500 FAIRVIEW

MARCH 19, 2013

**PUDA REVISION
SUBMITTAL
03.19.2010**

**02.12.2013
PRE-SUBMITTAL
CONFERENCE
MEETING**

STREETScape IMPROVEMENTS

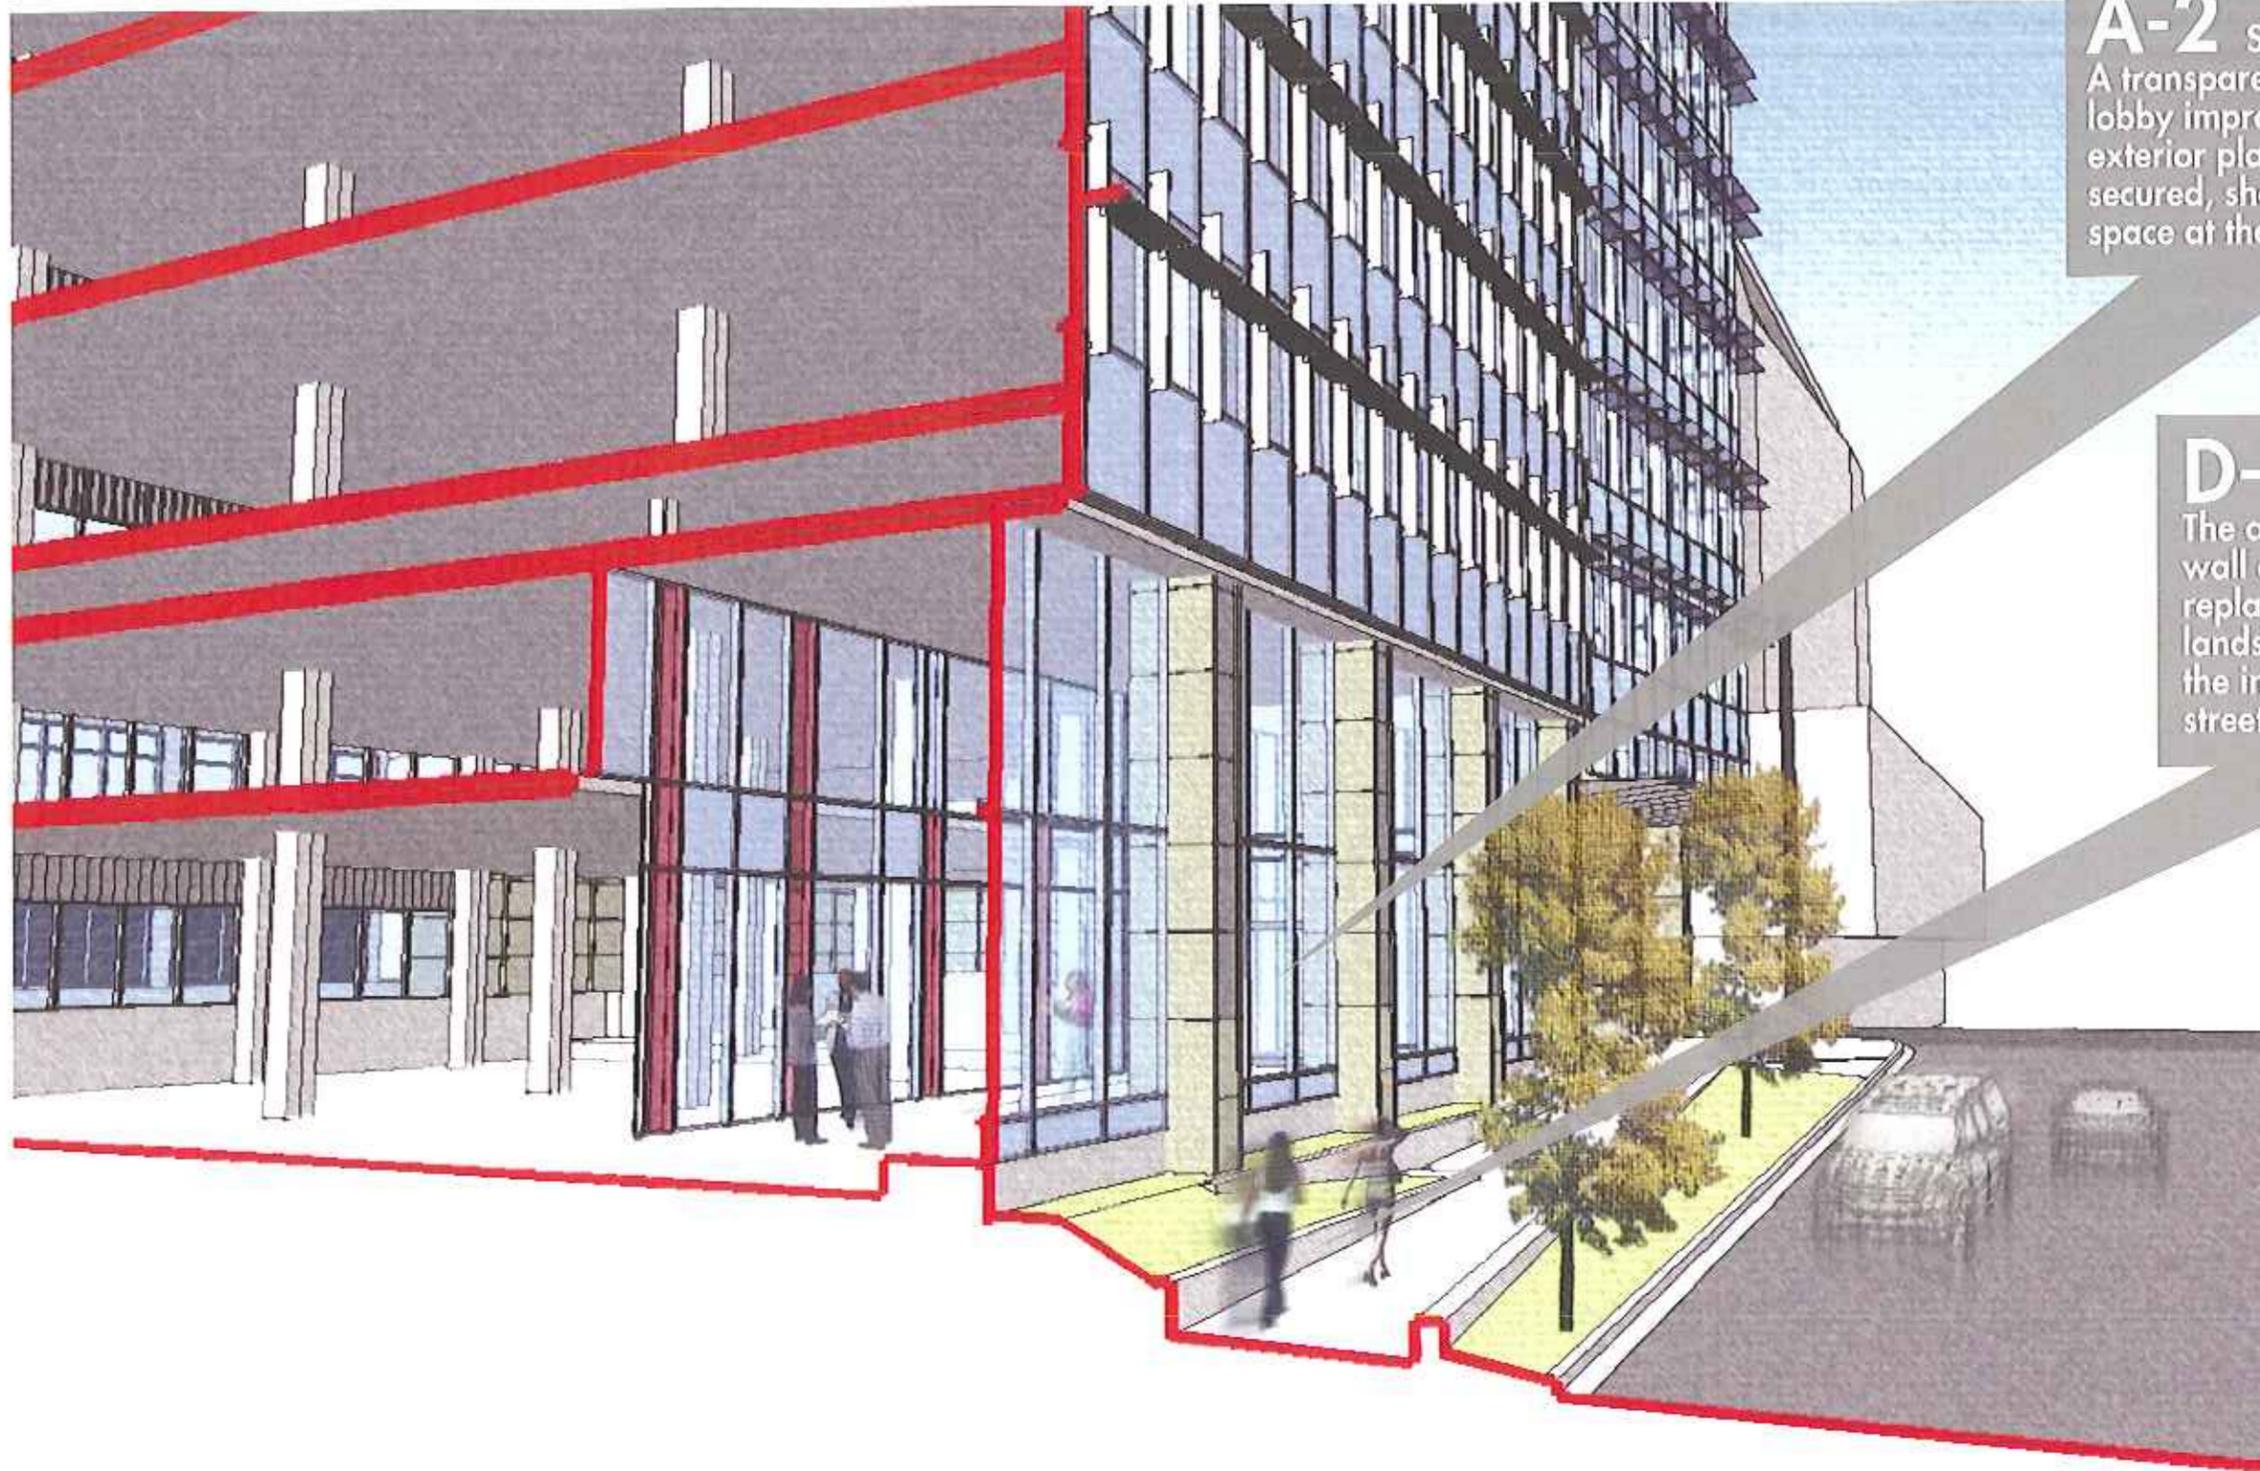
D-1 ENTRANCES VISIBLE FROM THE STREET - The main entry has been shifted to the prominent corner, next to retail, thereby improving visibility and reinforcing safety.

IMPROVED STREET CONNECTION

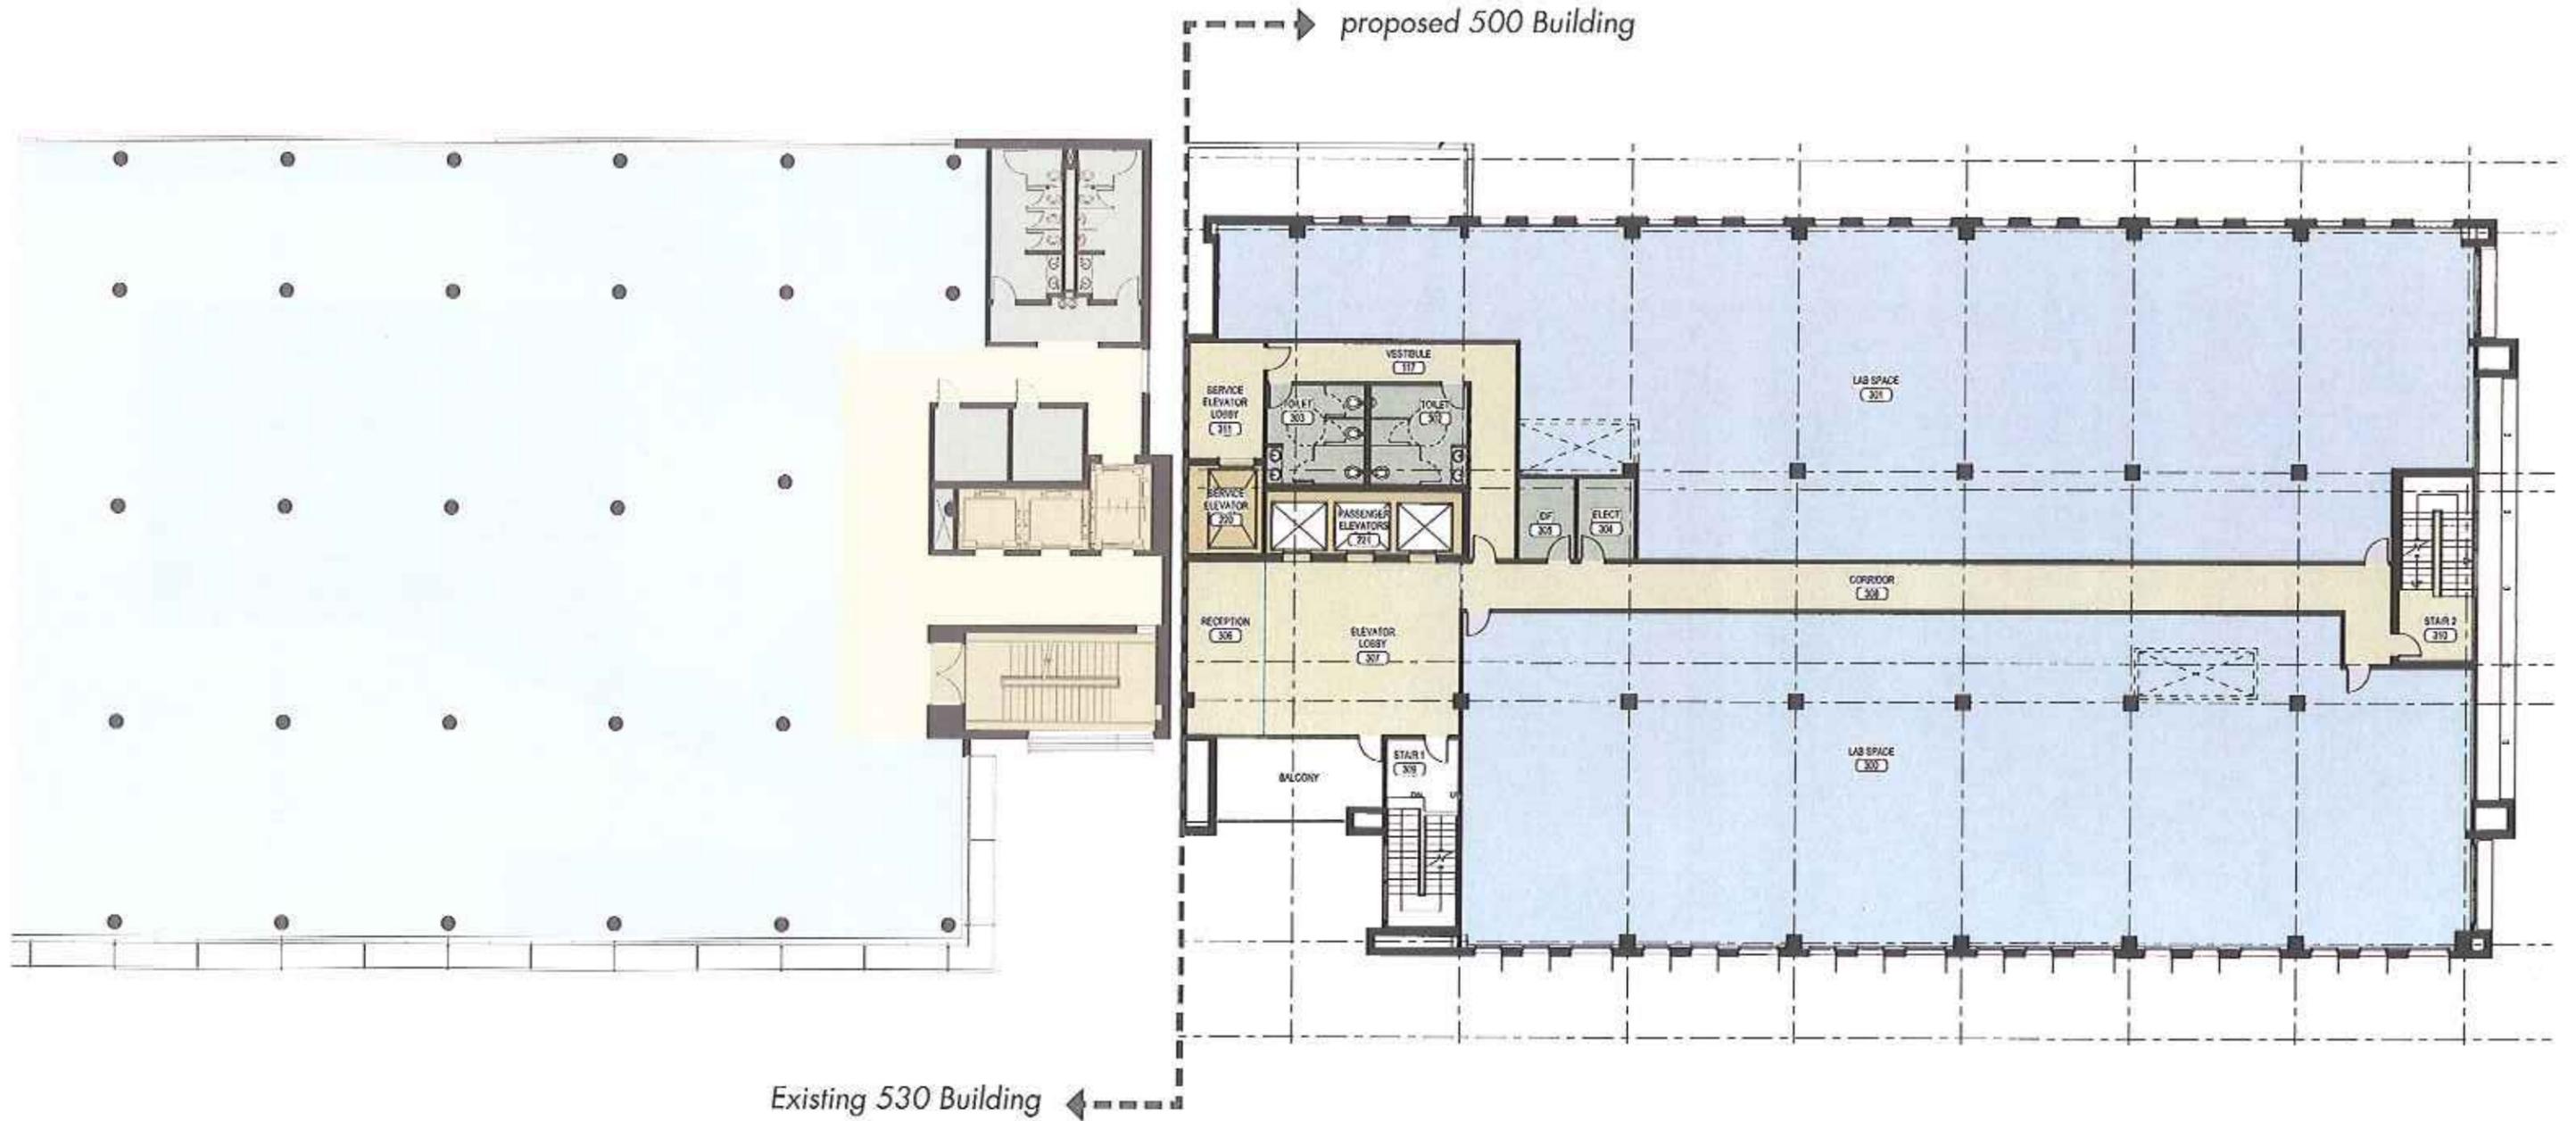
A-2 STREETScape COMPATIBILITY
A transparent, high-ceiling interior gallery/ lobby improves upon the previously approved exterior plaza and colonnade by offering a secured, sheltered and transparent public space at the street edge.

D-3 RETAINING WALLS
The approved retaining wall at mid-block has been replaced with a cascading landscape, thereby increasing the interior connection to the street.

PROPOSED TYPICAL FLOOR PLAN

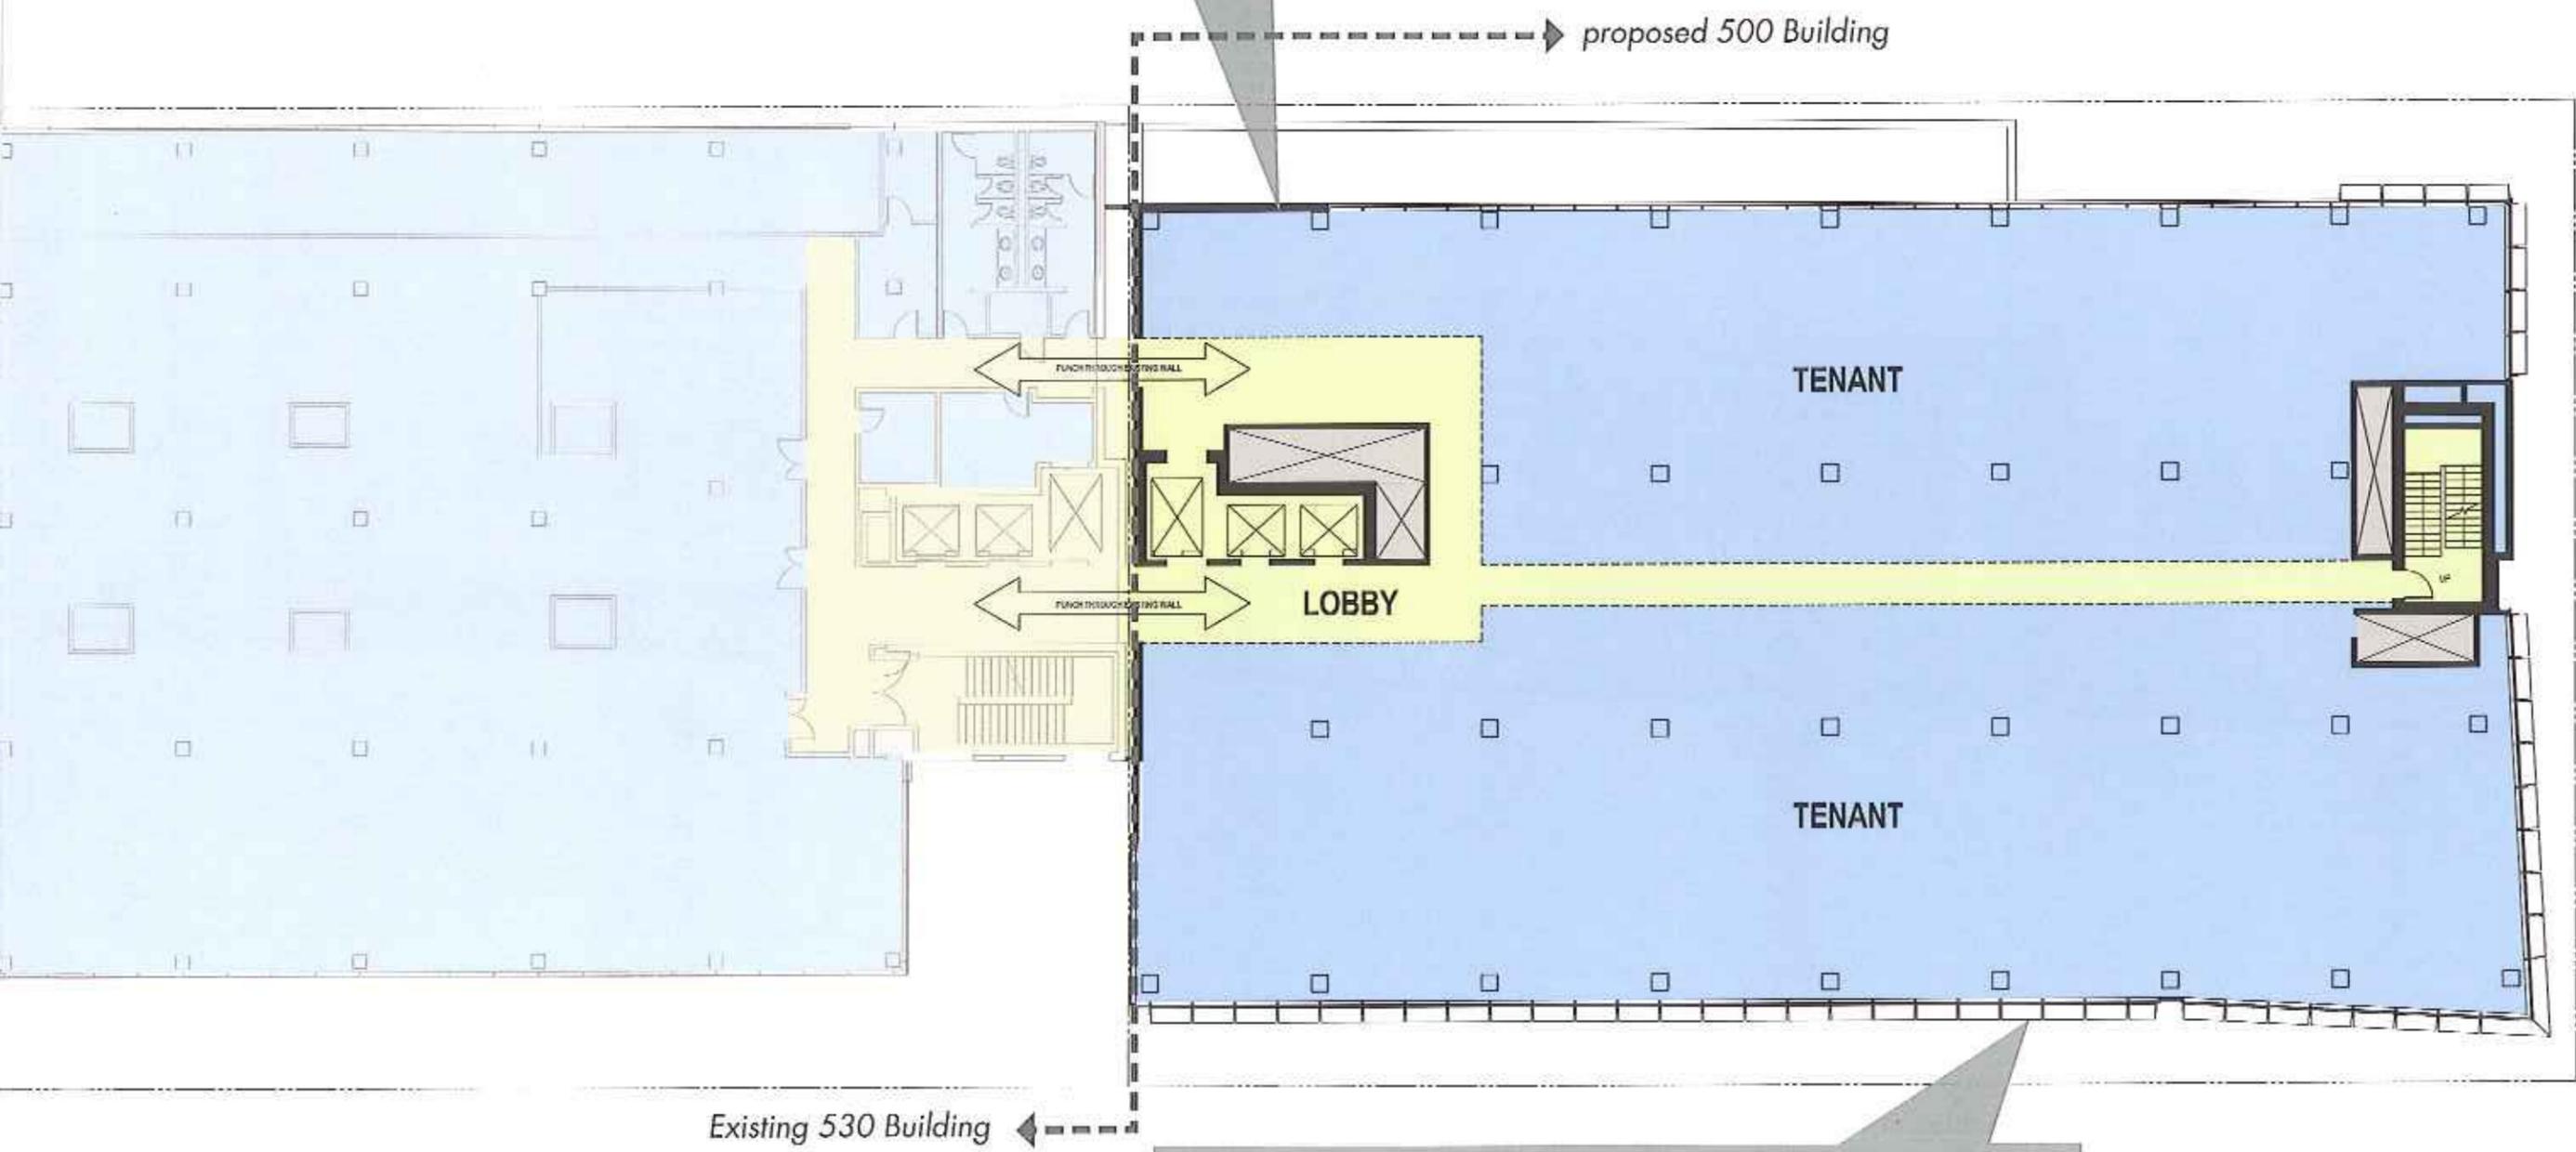
A-5 RESPECT FOR ADJACENT SITES
The proposed design maintains the increased setbacks and expands the opaque privacy-wall area established in the approved design

C-2 ARCHITECTURAL CONCEPT AND CONSISTENCY
Increased use of glass and spandrel in lieu of opaque, heavy material creates a lighter street presence and greater access to daylight
